URGENT - Field Safety Notification Medical Device Correction

Philips HeartStart MRx Monitor/Defibrillator on exceptionally rare occasions may exhibit abnormal behavior when operating using a single battery as the sole source of power.

Figure C: AC Module Removal

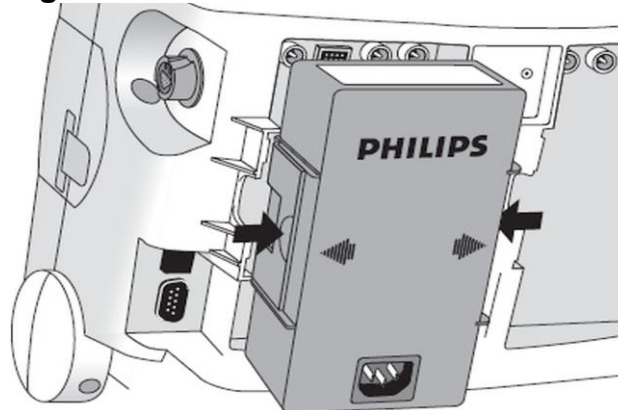
- a. Remove the AC module from the MRx, rather than unplugging the cord from AC mains (see Figure C).
